Amendments to the Drawings:

Attachment: Replacement Sheet
Annotated Sheet Showing Changes

Remarks/Arguments

Fig. 14

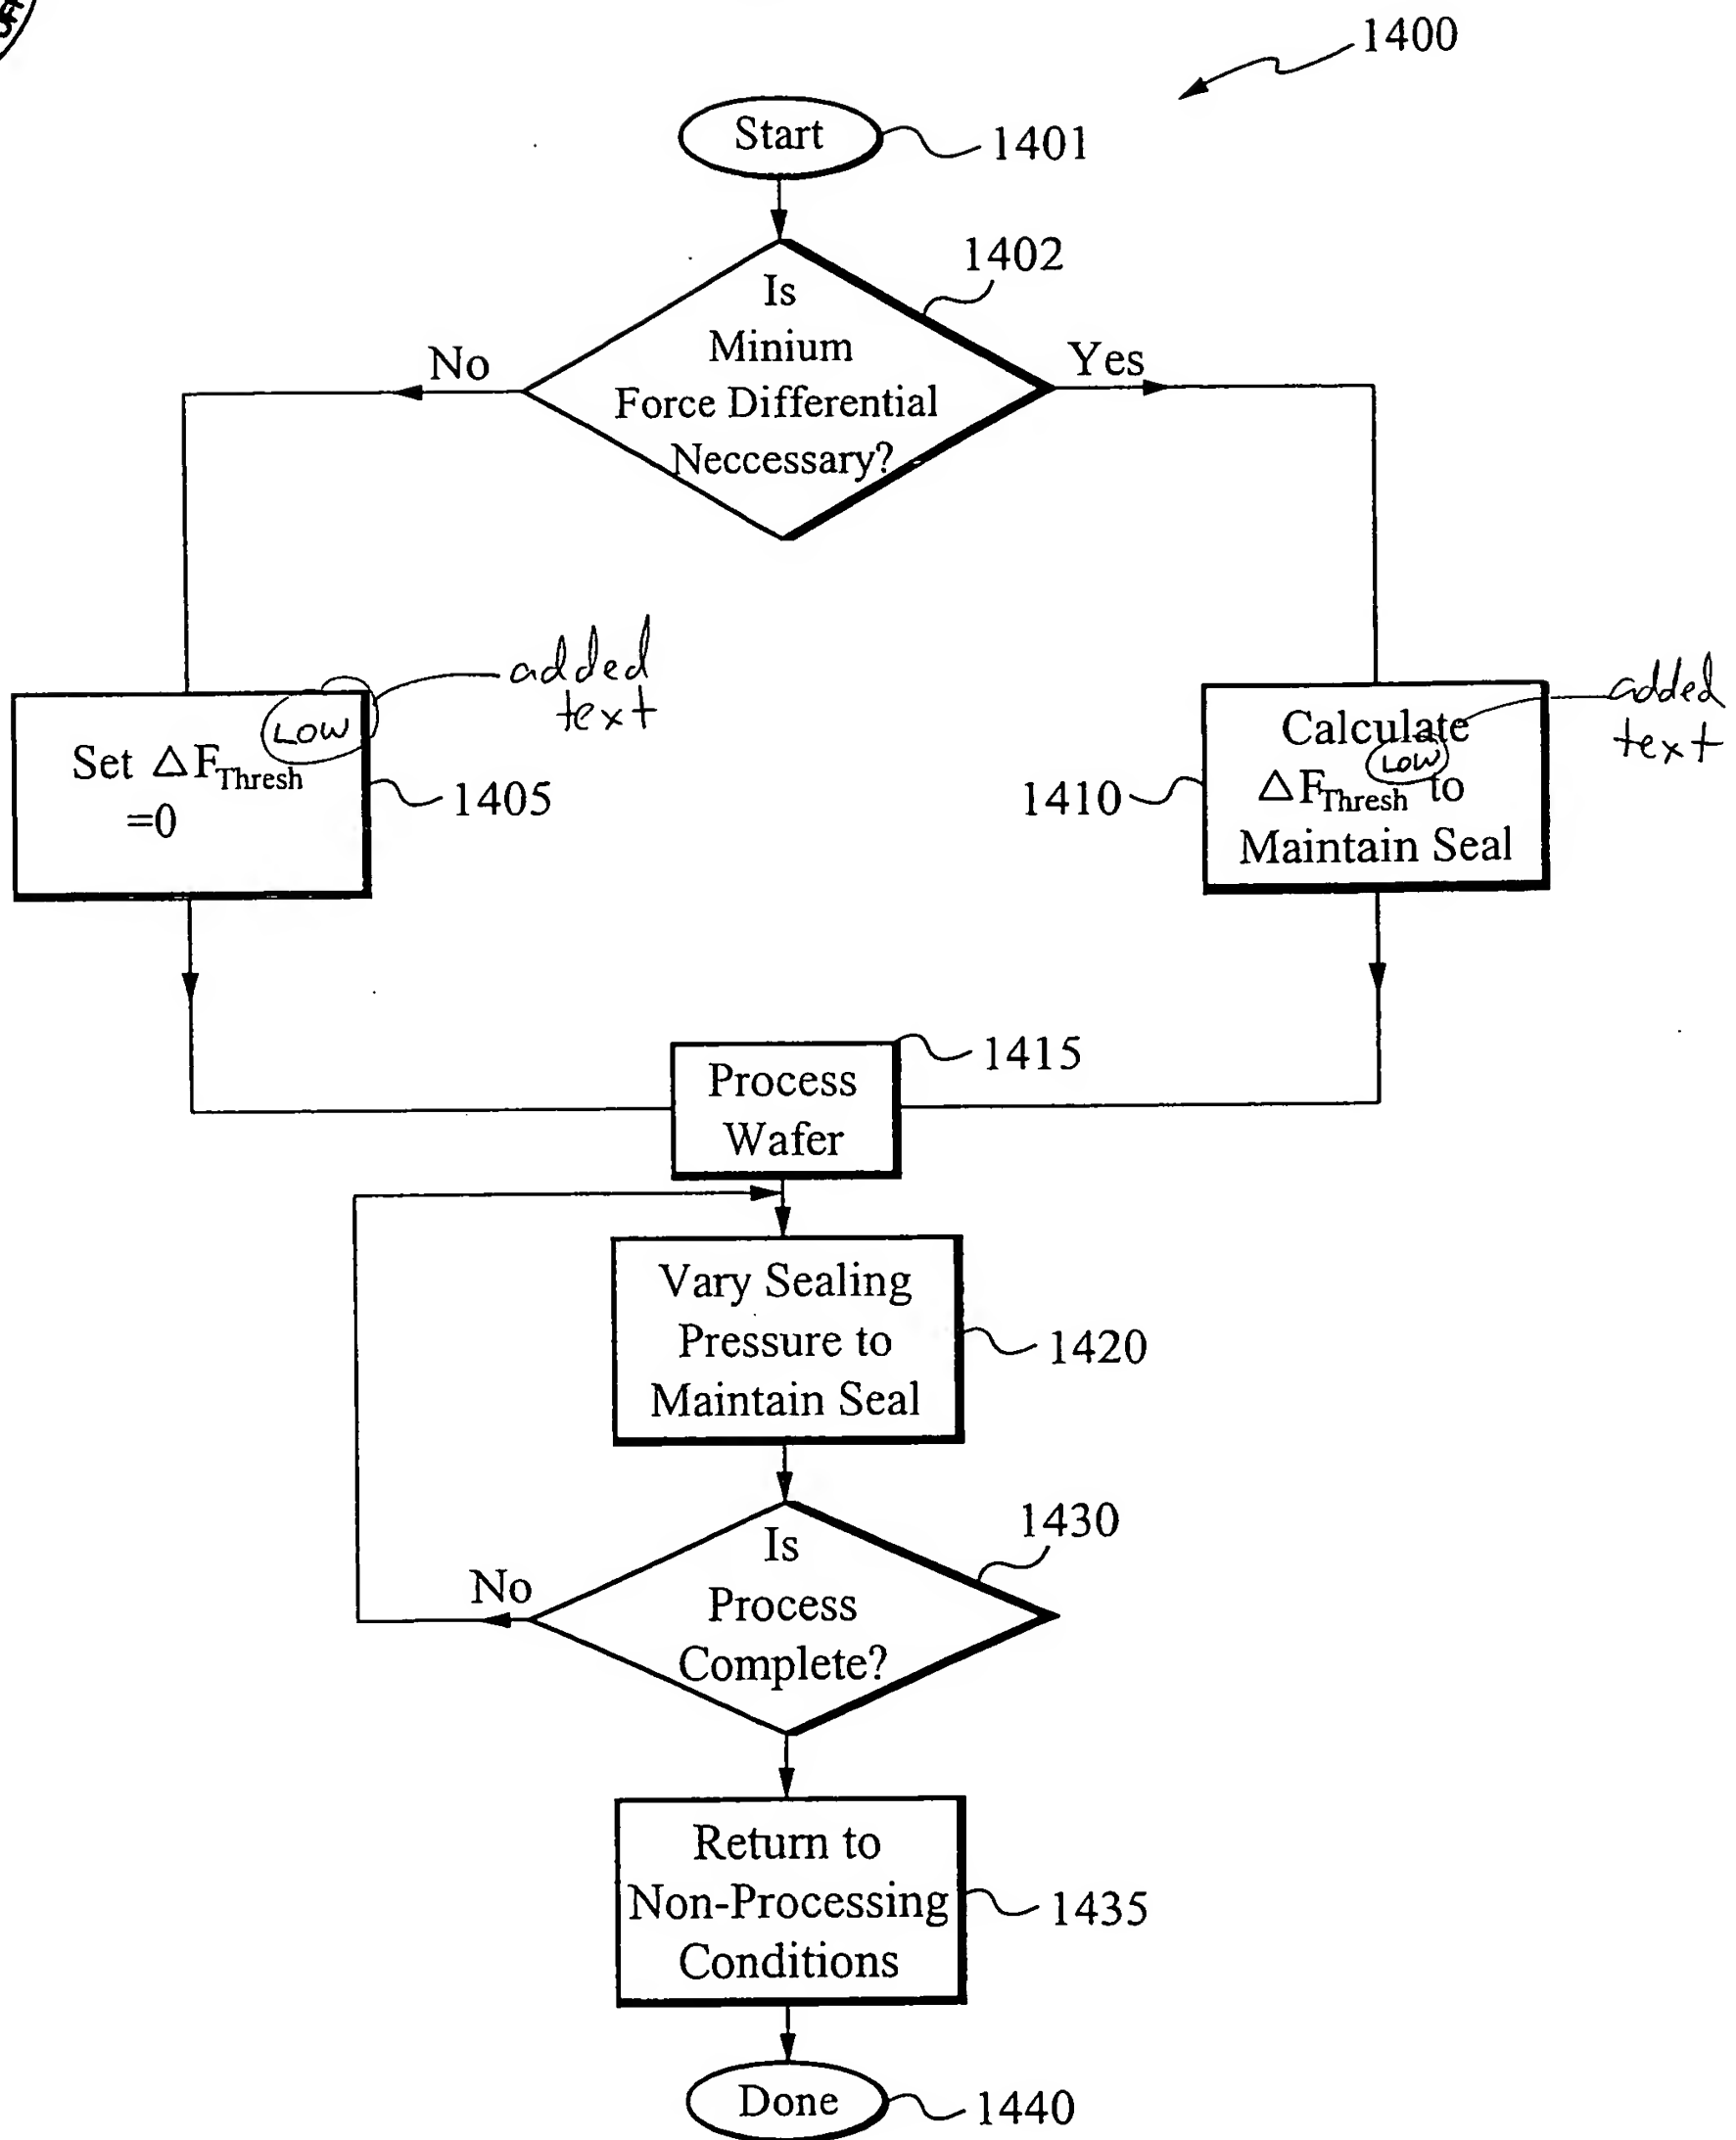
The attached sheet of a drawing includes changes to Figure 14. Figure 14 has been changed to more clearly show that the ΔF_{thresh} is actually a lower bound for ΔF and thus has been more clearly labeled $\Delta F_{\text{thresh}}^{\text{LOW}}$. That portion of the Specification describing Figure 14 has also been amended to conform to Figure 14 and refer to $\Delta F_{\text{thresh}}^{\text{LOW}}$.

The Applicant has also amended the Specification to use more descriptive terminology. Where the Specification discusses a lower threshold for ΔF , the term ΔF_{thresh} has been replaced with the term $\Delta F_{\text{thresh}}^{\text{LOW}}$. Where the Specification discusses an upper threshold for ΔF , the term ΔF_{thresh} has been replaced with the term $\Delta F_{\text{thresh}}^{\text{UPP}}$. This mere rephrasing of terms is not new matter. M.P.E.P. § 2163.07(I) (Rev. 5, August 2006).
